RE: Conifer Metropolitan District – Total Dissolved Solids Limit Variance Request RFI Response
COX-0047392

On behalf of Conifer Metropolitan District, AquaWorks DBO is following up on information that the Water Quality Control Division has requested for a Variance Request.

AquaWorks DBO submitted a Variance Request on July 14, 2021, for relief from the total dissolved solids and chloride limits on behalf of the Conifer Metropolitan District. The request is currently under review by the Water Quality Control Division. On September 21, 2022, the Division requested clarification on the following items to aid with its review of the request:

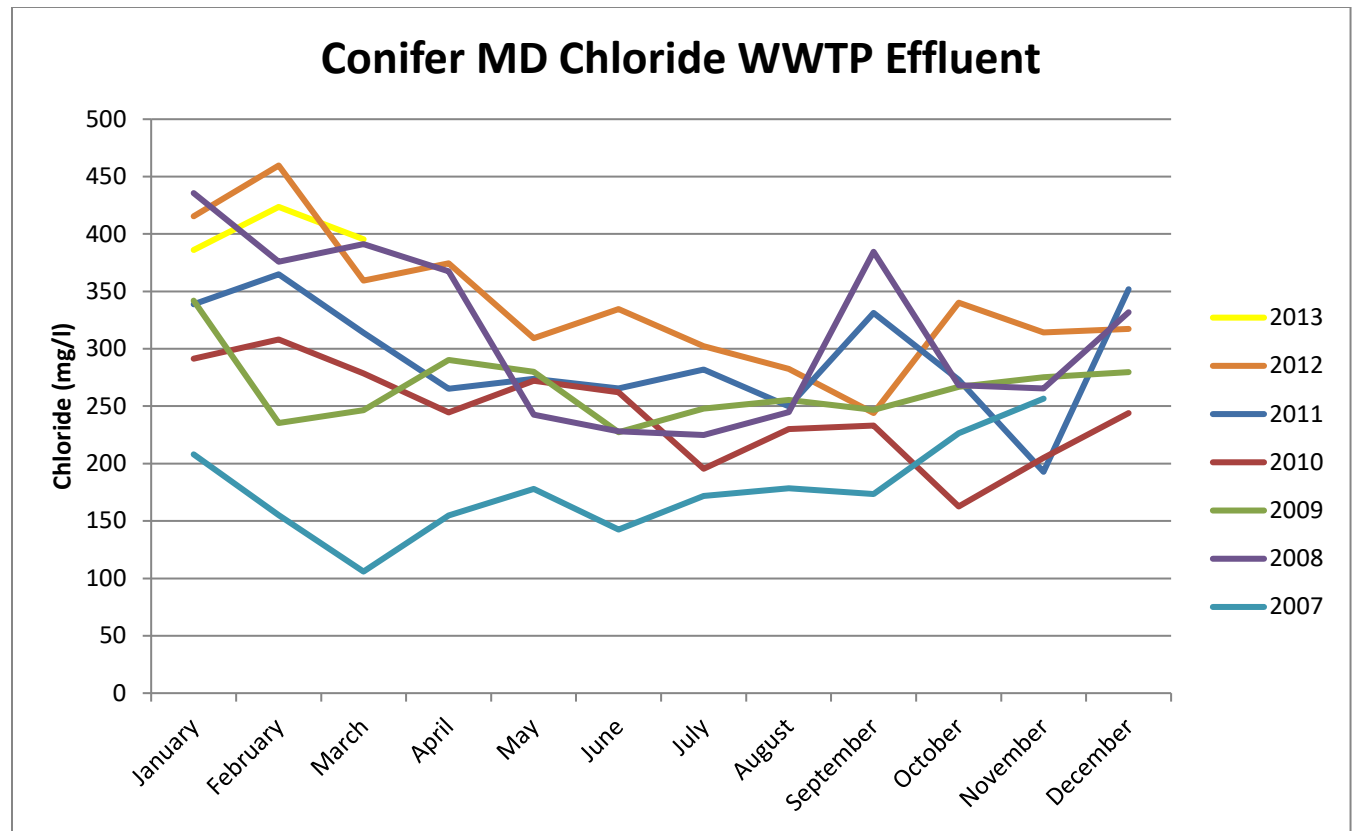
WWTP effluent was sampled for chloride 2007 through 2013. AquaWorks has the following records for chloride in the WWTP effluent:

The following is a graph of the chloride results from the WWTP effluent from 2007 to 2013. The concentrations of chloride are highest in January and generally lowest in late spring.

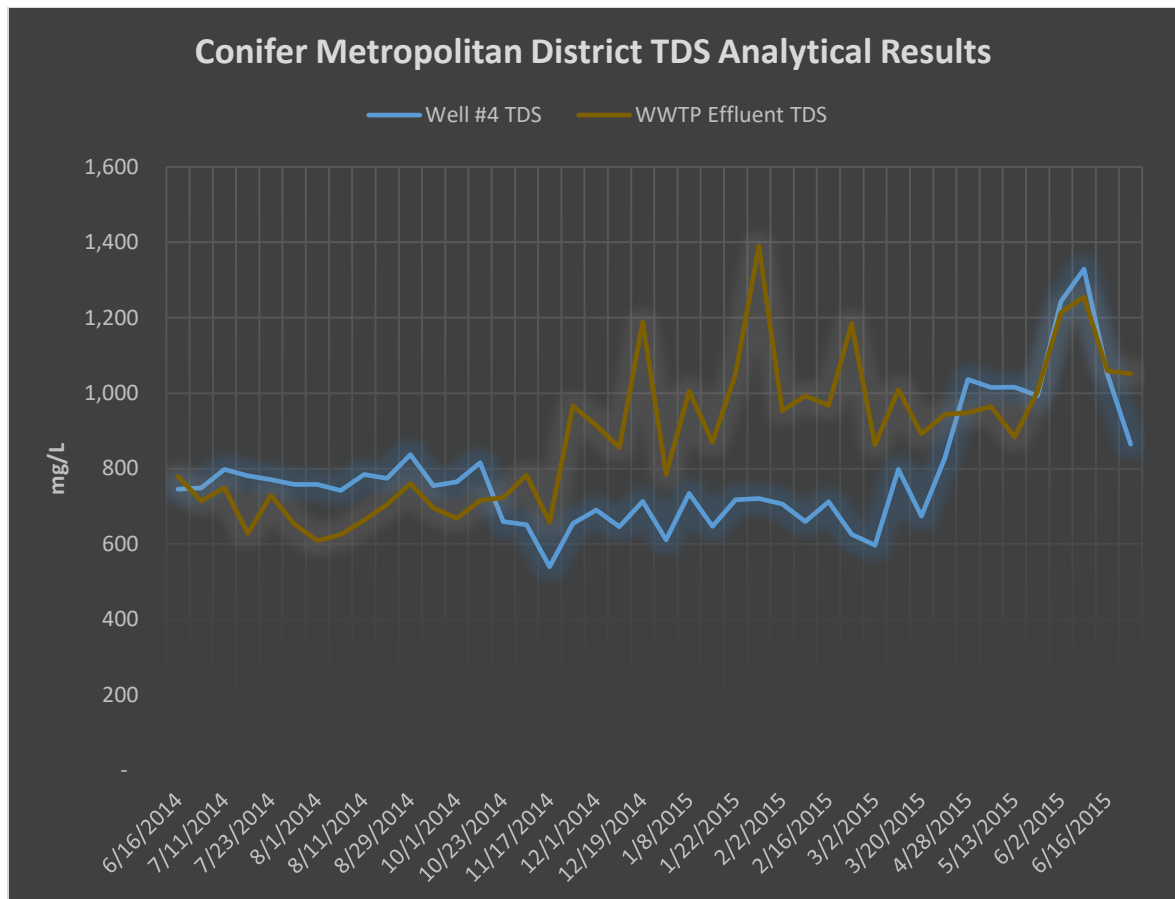
Prior to the enforcement, little sampling for TDS was conducted as it was not a regulated item. A sample from raw water well VW-2 was taken on 12/30/2005. The result for TDS was 198 mg/L. Once the TDS limit was introduced in 2014, the District began regularly sampling for TDS. The data below includes samples collected from the raw water wells #3 and #4 and the WWTP effluent.

The following is a graph of the TDS results from the raw water wells and the WWTP effluent from 2014-2015. It shows the relationship between the TDS concentration in Well #4 and the WWTP effluent over time.

TDS readings on November 4, 2021

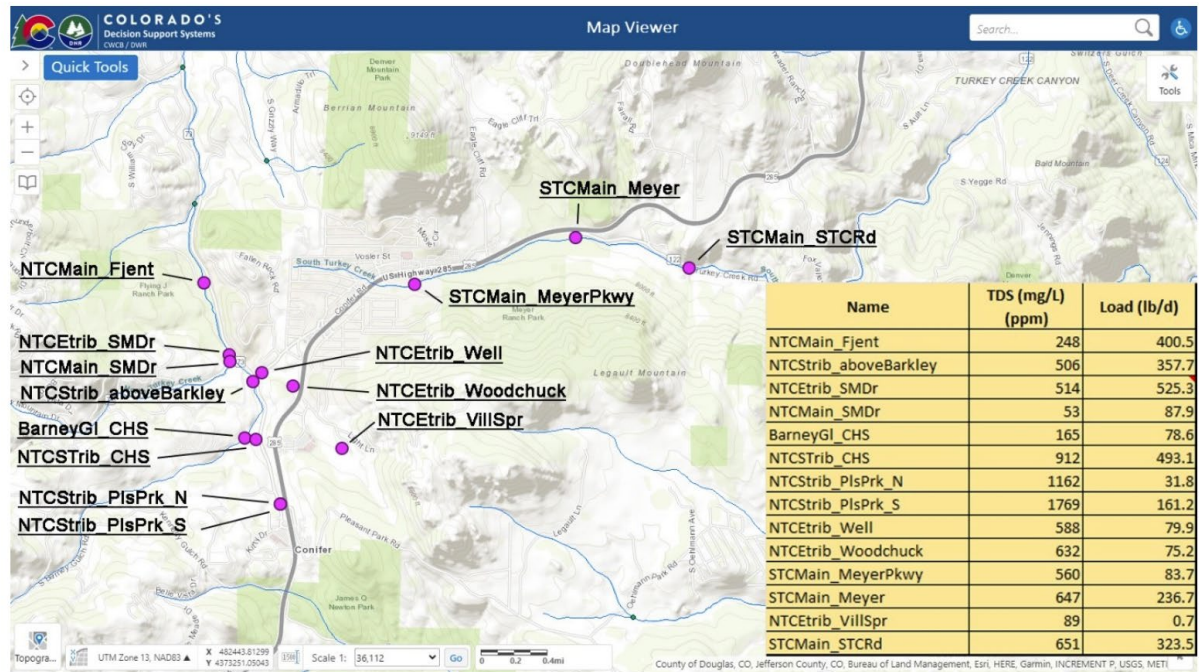
4) Do you have any groundwater data for TDS and chloride for offsite properties adjacent to the CMD?

The information about TDS concentration and loading in the figure below is posted on Conifer Area Council's website. It is noteworthy that the highest concentrations are adjacent to Highway 285. Two of the results, PlsPark-N (1,162 mg/L) and PlsPark-S (1,769 mg/L), are higher than the average Conifer MD's WWTP effluent TDS (838 mg/L) between June 2014 and July 2015. These results support the District's position that the TDS in the groundwater is primarily originating from CDOT's de-icing operations:

The CAC Water Resources Study/Action Team has started to monitor total dissolved solids (TDS) at various points in Conifer. Three are tap water readings (Staples, Safeway, King Soopers, Church). All other readings are locations on main streams or tributaries in open channels or culverts.

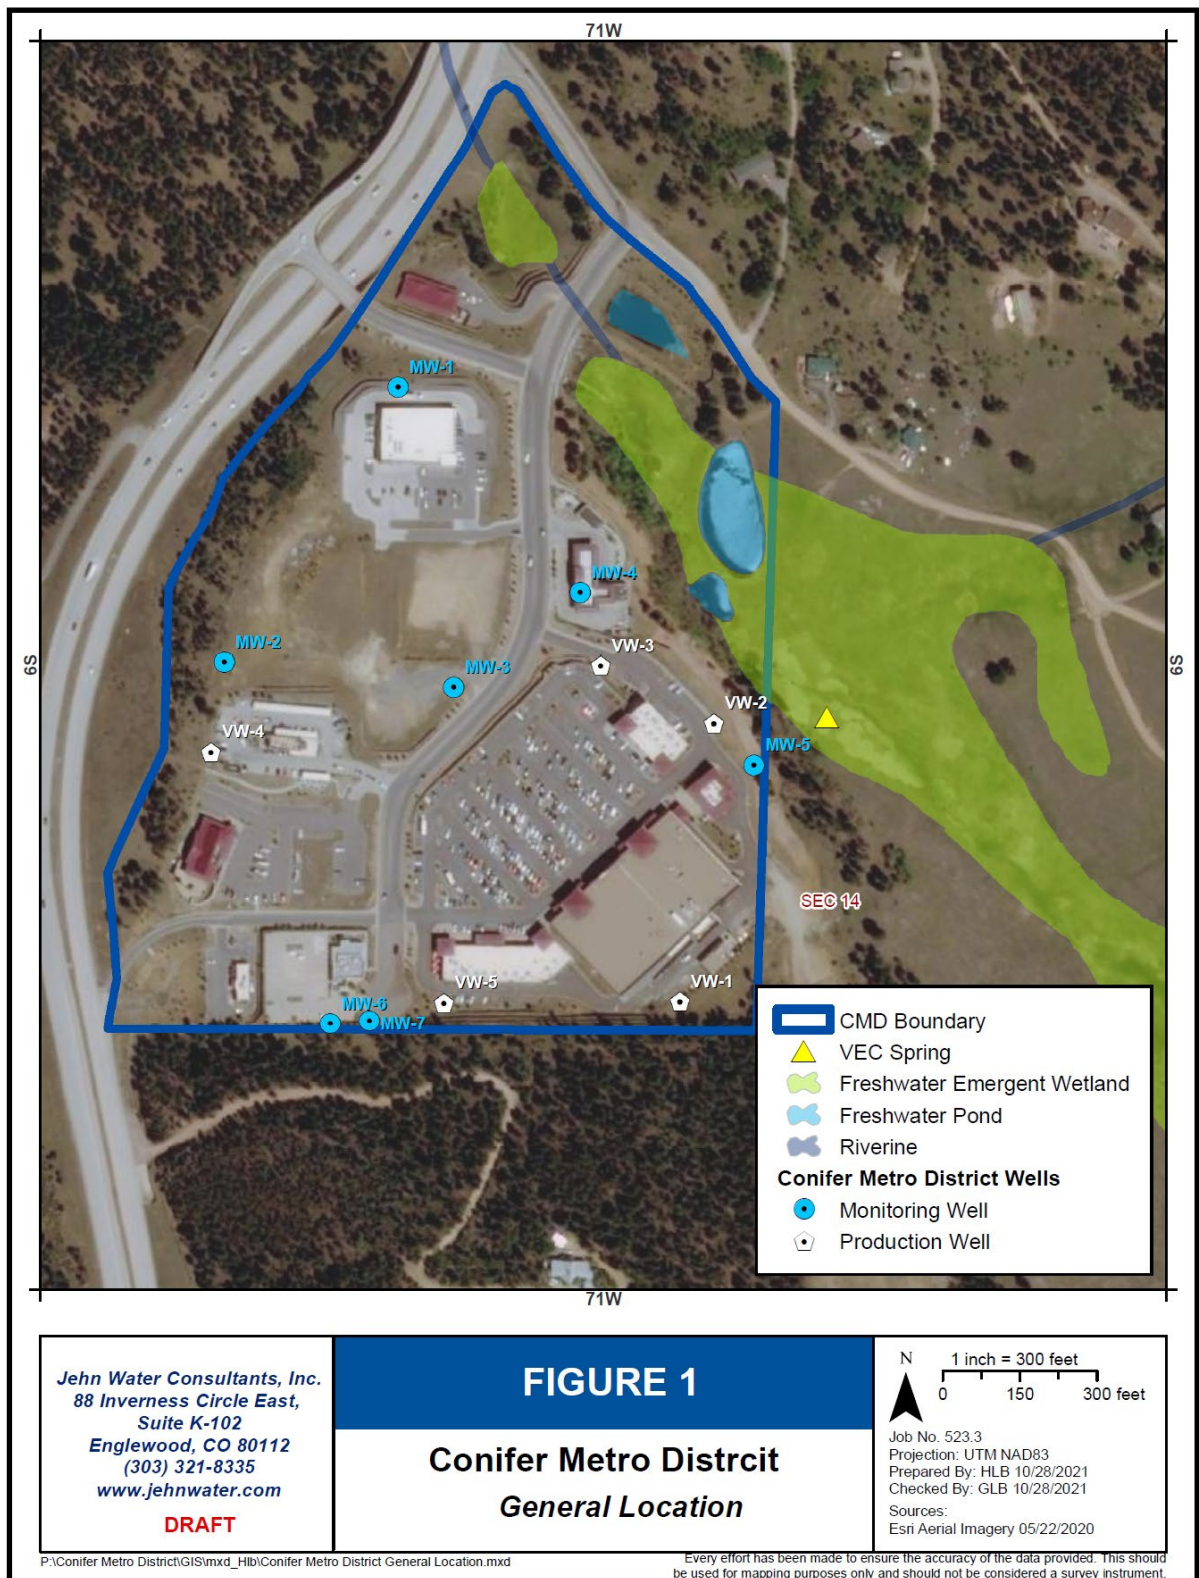
- 5) The variance request refers to a raw water well that was installed in 2018 with a reported TDS concentration of 417 mg/l. Where is this well located?

The image below shows the location of Well #5 (labelled as “VW-5”).
